MFN 06-119
Supplement 1

Subject: **Response to NRC Request for Additional Information Letter No. 16 Related to ESBWR Design Certification Application – Piping Design – RAI Numbers 3.12-1S1, 3.12-2S1, 3.12-4S1 through 3.12-10S1, 3.12-12S1, 3.12-13S1, 3.12-16S1, 3.12-19S1, 3.12-20S1, 3.12-23S1, 3.12-24S1 through 3.12-26S1, 3.12-28 S1 through 3.12-37S1 – Supplement 1**

**RAI Numbers 3.12-1S1, 3.12-2S1, 3.12-4S1 through 3.12-10S1,
3.12-12S1, 3.12-13S1, 3.12-16S1, 3.12-19S1, 3.12-20S1, 3.12-
23S1, 3.12-24S1, through 3.12-26S1, 3.12-28 S1 through 3.12-37S1
Supplement 1**

Figure 3.7-37. Alternative Damping Values for Response Spectra Analysis of ASME Section III, Division I Class 1, 2, and 3, and ASME/ANSI B31.1 Piping Systems.

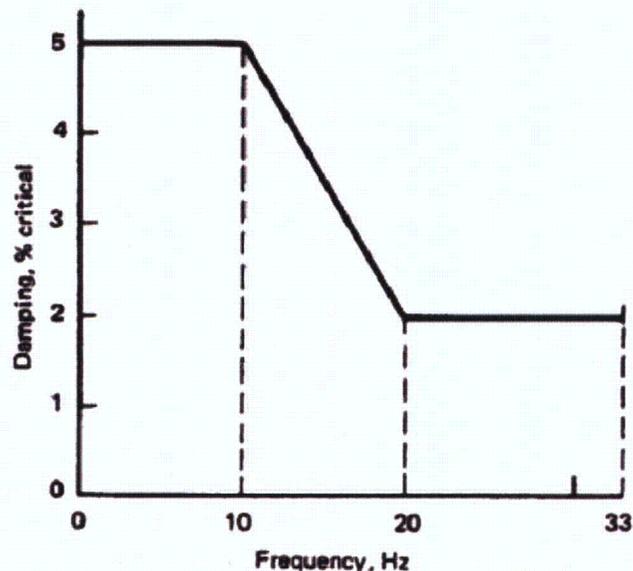
RAI 3.12-19

New figure 3.7-37 note 4 has been modified to address annulled Code Case N-420.

For ASME Section III, Division 1 Class 1, 2, and 3, and ASME/ANSI B31.1 piping systems, damping values specified in Figure 3.7-37 may be used. ~~of ASME Code Case N-411-1 may be used as permitted by Regulatory Guide 1.84, in place of Regulatory Guide 1.61 damping. ASME Code Case N-411-1 damping cannot be used for analyzing linear energy absorbing supports designed in accordance with ASME Code Case N-420.~~ The damping values shown in Table 3.7-1 are applicable to all modes of a structure or component constructed of the same material. Damping values for systems composed of subsystems with different damping properties are obtained using the procedures described in Subsection 3.7.2.13.

¹ See Figure 3.7-37 for alternative ~~D~~damping values for response spectra analysis of ASME Code Case N-411-1 may be used, as permitted by the USNRC Regulatory Guide 1.84, for ASME Section III, Division 1, Class 1, 2, and 3, and ASME/ANSI B31.1 piping systems. ~~These damping values are applicable in analyzing piping response for seismic and other dynamic loads filtering through building structures in high frequency range beyond 33 Hz.~~
